Title - Sujet Bow Windlass Parts (GSM)	
Solicitation No. - N° de l'invitation F2599-175002/A	Amendment No. - N° modif. 002
Client Reference No. - N° de référence du client F2599-175002	Date 2017-03-16
GETS Reference No. - N° de référence de SEAG PW-\$\$ML-055-26187	
File No. - N° de dossier 055ml.F2599-175002	CCC No./N° CCC - FMS No./N° VME
Solicitation Closes - L'invitation prend fin at - à 02:00 PM on - le 2017-04-04	Time Zone Fuseau horaire Eastern Daylight Saving Time EDT
F.O.B. - F.A.B. Plant-Usine: <input type="checkbox"/> Destination: <input checked="" type="checkbox"/> Other-Autre: <input type="checkbox"/>	
Address Enquiries to: - Adresser toutes questions à: Belcaid, Sidi	Buyer Id - Id de l'acheteur 055ml
Telephone No. - N° de téléphone (819) 420-2292 ()	FAX No. - N° de FAX () -
Destination - of Goods, Services, and Construction: Destination - des biens, services et construction:

Solicitation Amendment #2 is issued to publish the following changes to the Request For Proposal (RFP), the Questions and Answers and new documents.

Bow Windlass Parts (F2599-175002/A)

DIAGRAM OF CONNECTIONS.	
CLARKE CHAPMAN & Co. LTD.	GATESHEAD 8
DRC No. 68/03/54

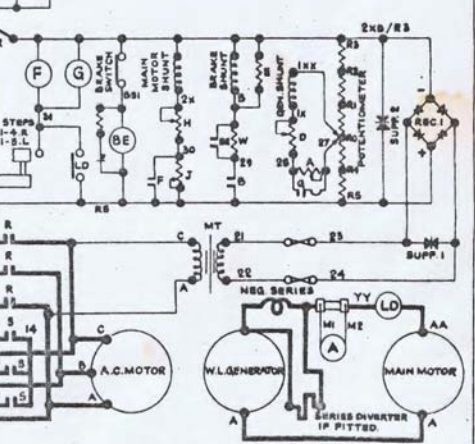
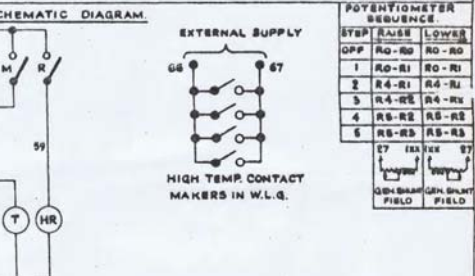
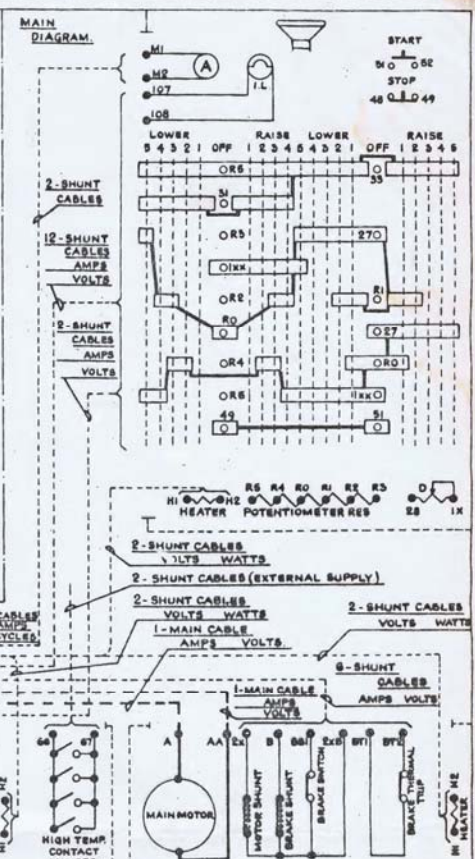
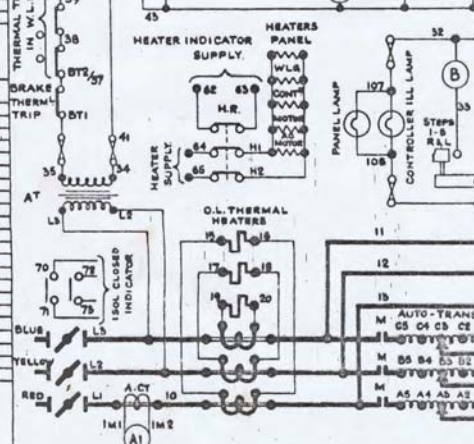
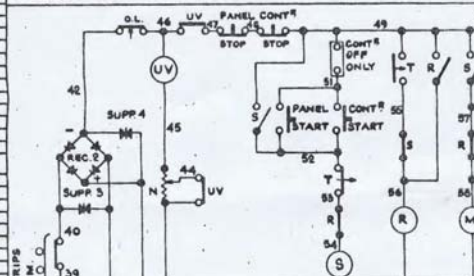
- 3) Publish the following documents under the file entitled "Griffon Windlass Photos" (Photos of the windlass) and its original diagram of electrical connections entitled "Electr-Diag-Griffon-68_93_54".**
